Project No. 05704-52-54A
October 22, 2019

Subject: RESPONSE TO CITY REVIEW COMMENTS
MEADOWS DEL MAR (THE BOUGAINVILLEA)
LOT 80: 5702 MEADOWS DEL MAR
PTS# 604841 – MEADOWS DEL MAR SDP
SAN DIEGO, CALIFORNIA

- References:
1. *City of San Diego Review Comments [for] Meadows Del Mar SDP, Project No. 60481*, LDR-Geology, dated September 30, 2019.
 2. *Update Geotechnical Report, Meadows Del Mar (The Bougainvillea) Tract No. 13684, Lot No. 80 (5702 Grand Del Mar Way), San Diego, California*, prepared by Geocon Incorporated, dated March 9, 2009 (Project No. 05704-52-54).
 3. *Addendum Update Geotechnical Report, Report of Testing and Observation Services During Regrading Operations, Grand Del Mar Lot 80, San Diego, California*, prepared by Geocon Incorporated, dated November 13, 2009 (Project No. 05704-52-54).

SCALE 1" = 60'	DATE 10 - 22 - 2019
PROJECT NO. 05704 - 52 - 54A	FIGURE 1
SHEET 1 OF 1

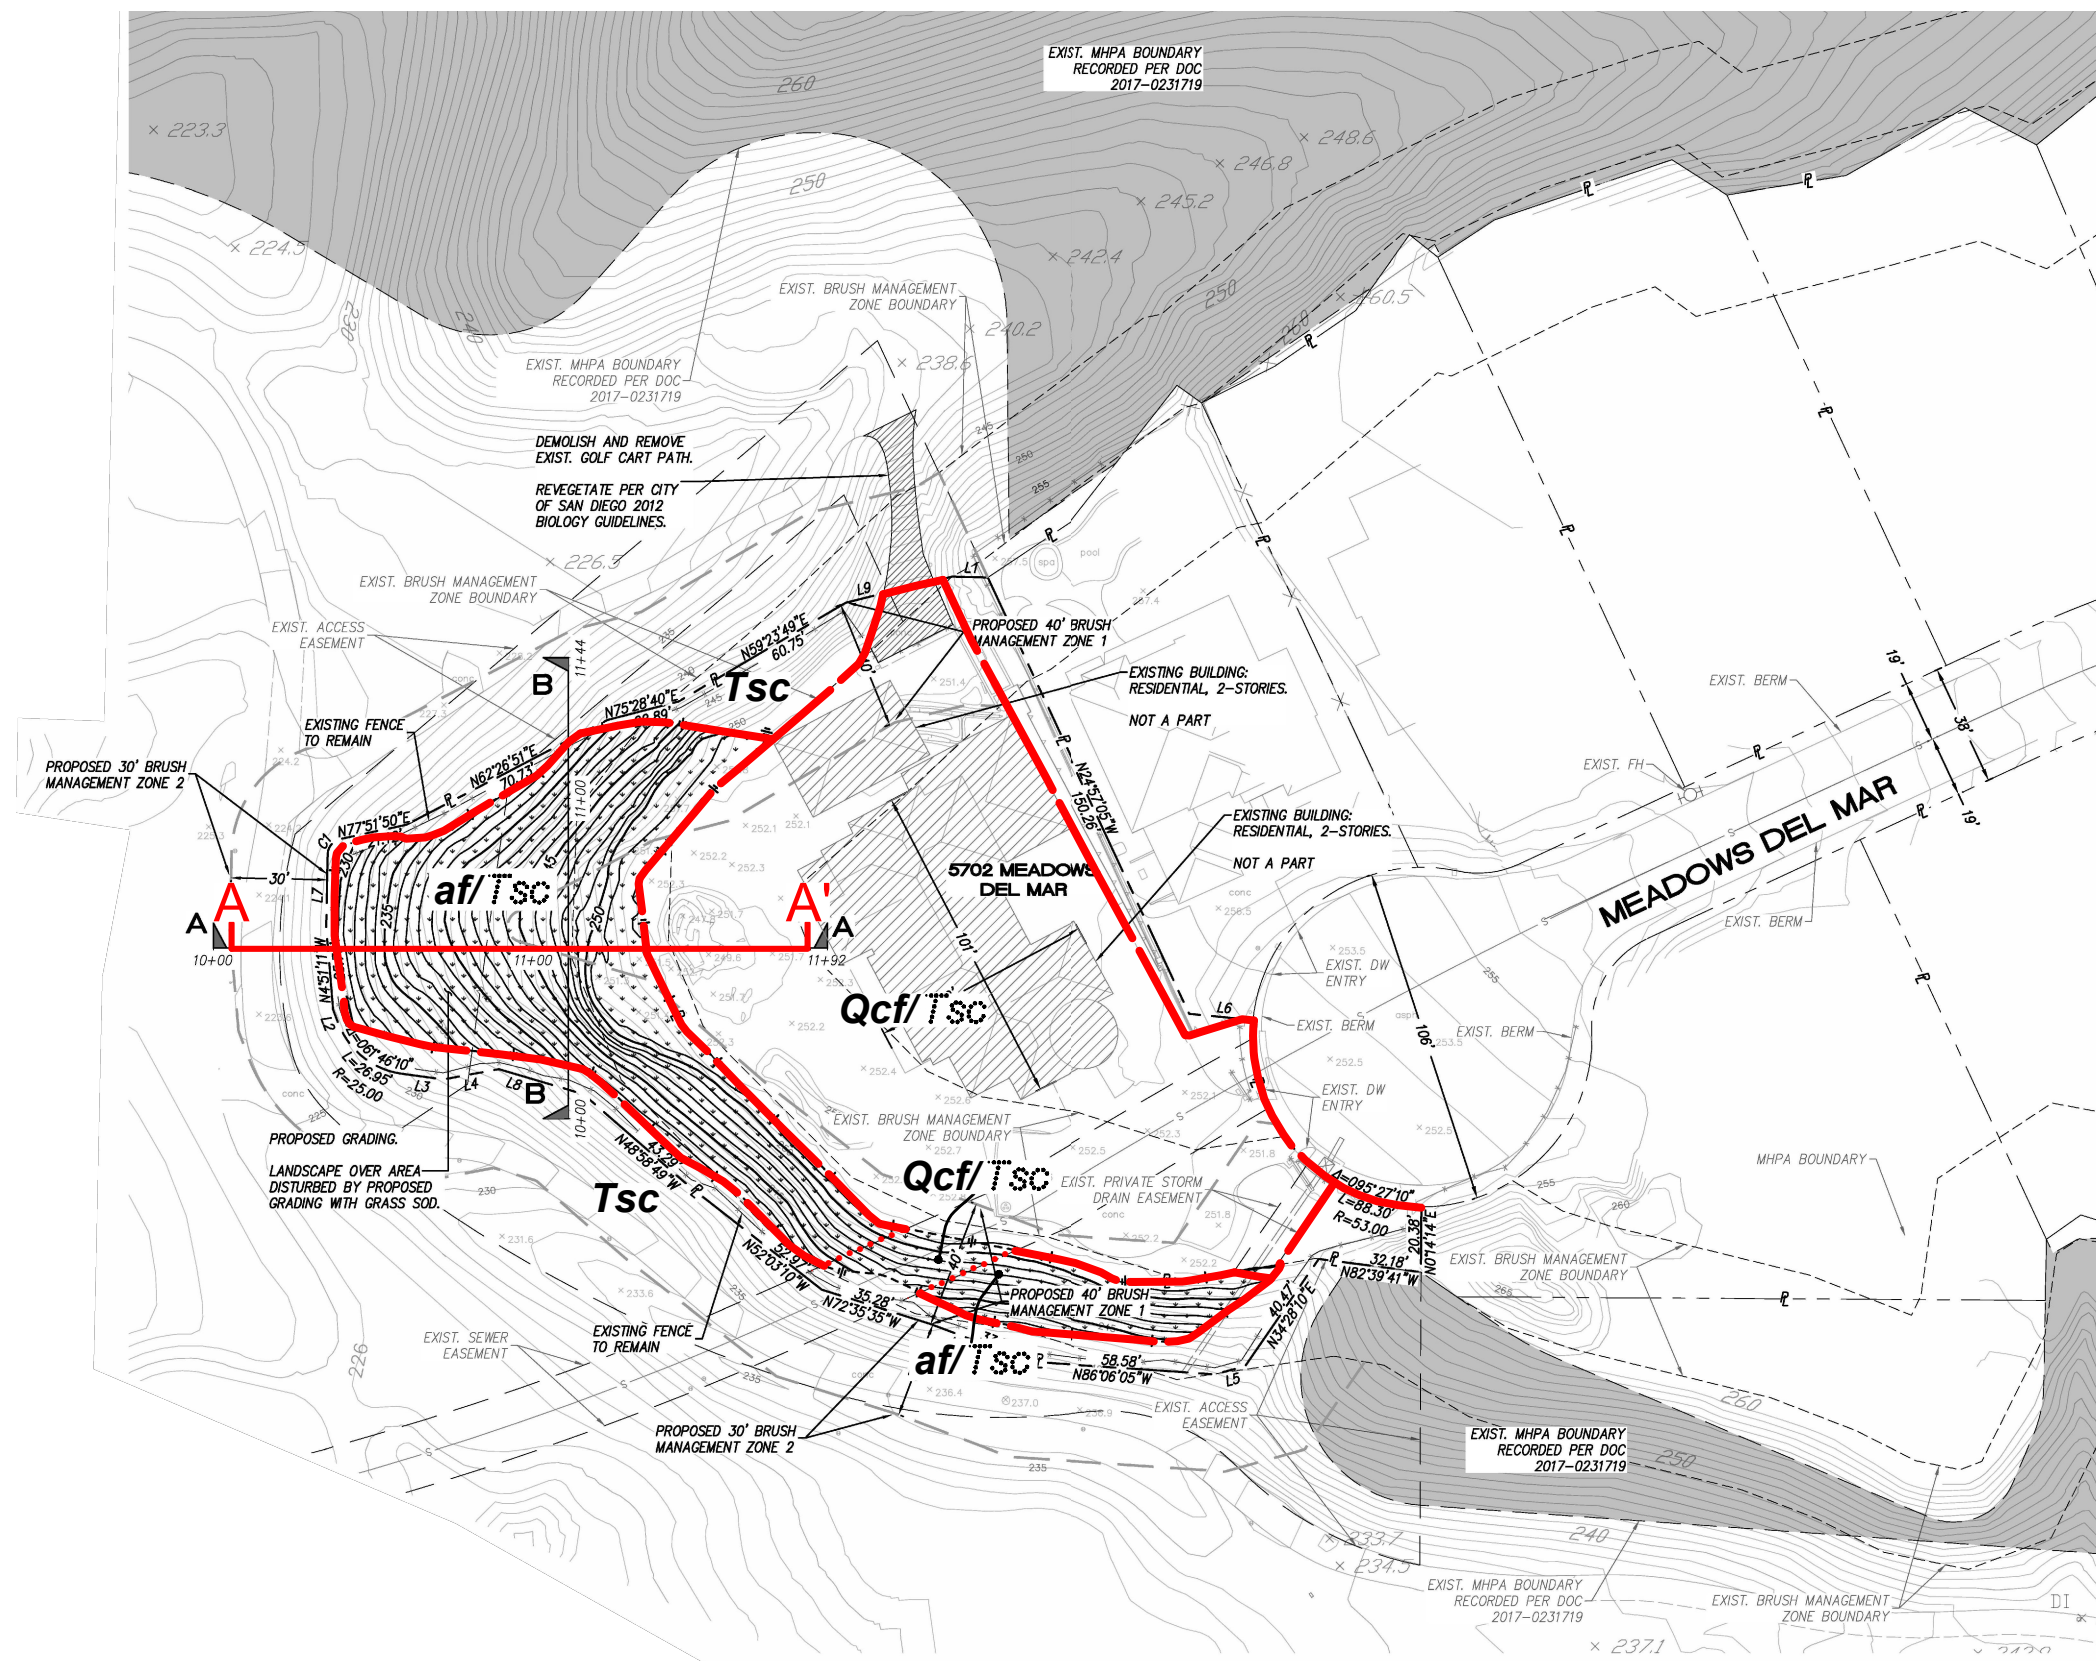
Comment No. 6: *Provide an updated, site-specific geologic map that depicts the current geologic conditions, existing and proposed development. Circumscribe the recommended limits of remedial grading (if applicable).*

Response: Figure 1 presents a site-specific Geologic Map depicting the current geologic conditions and additional grading subsequent to the referenced report dated November 13, 2009. The additional grading has been completed.

FIGURE 2

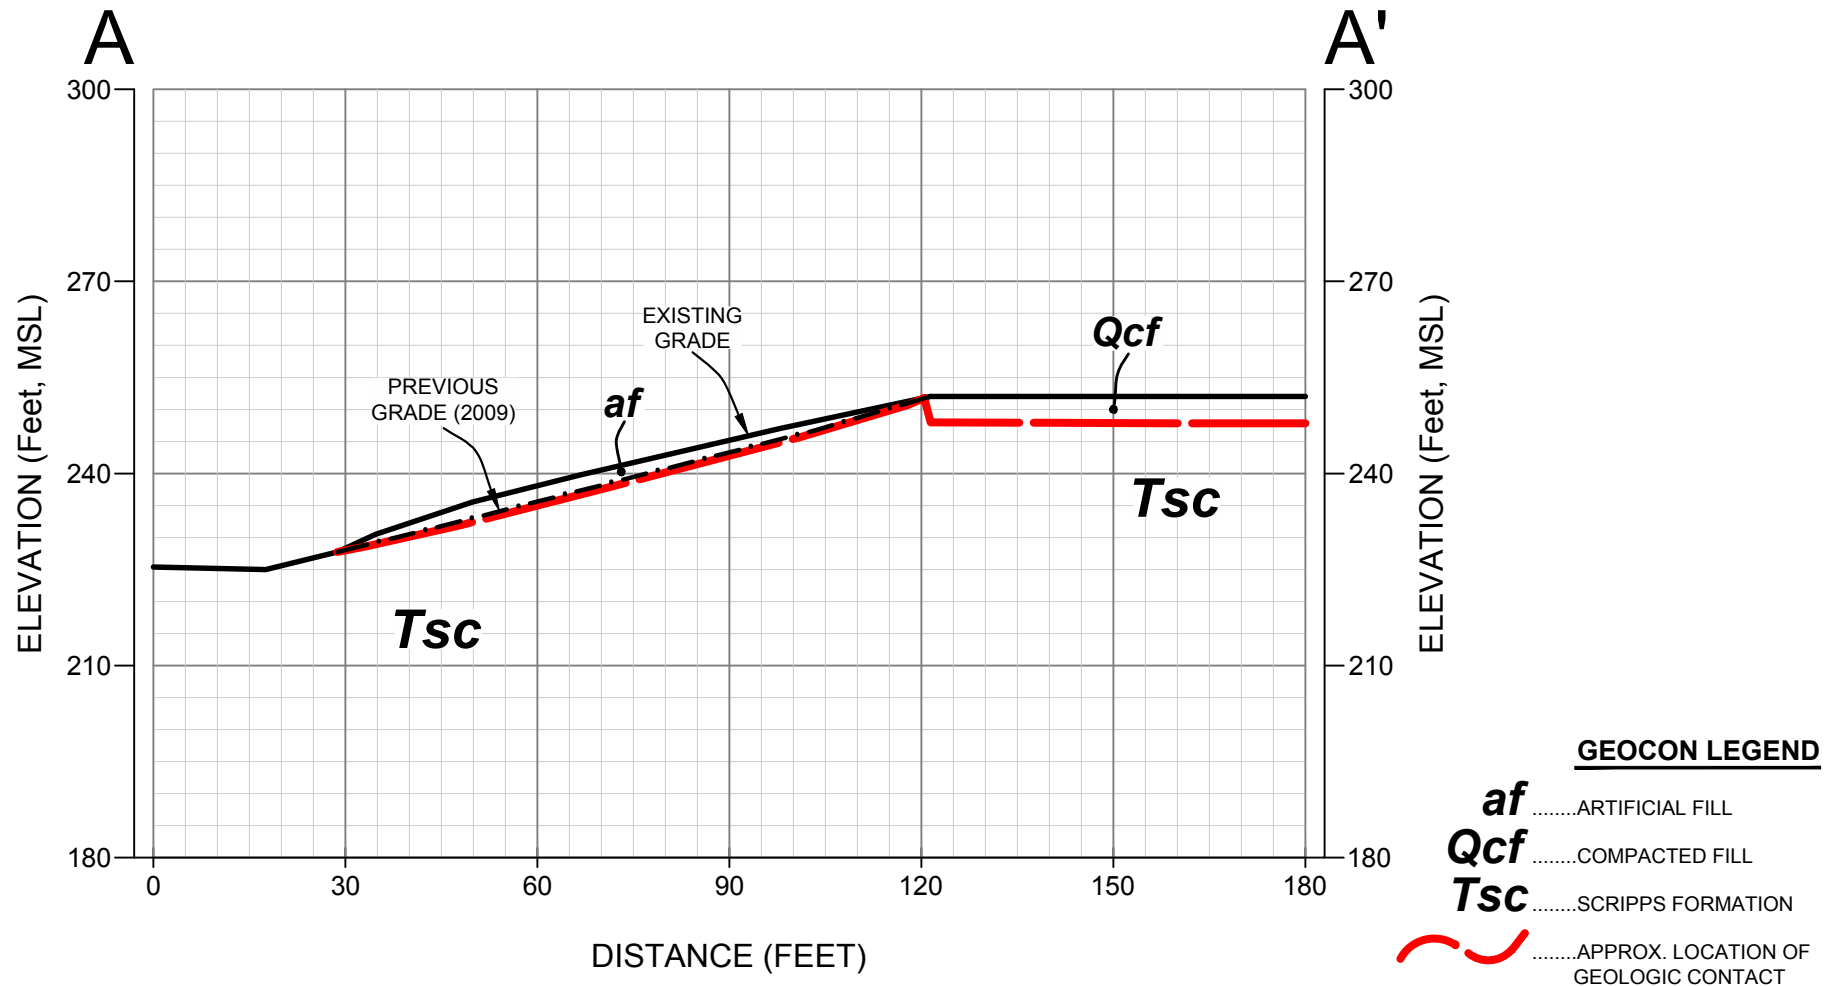
Comment No. 7: *Provide representative geologic/geotechnical cross section that shows the existing and proposed grades, distribution of fill and geologic units.*

Response: Figure 2 presents a Geologic Cross-Section presenting the existing and proposed grades, and distribution of fill and geologic units.
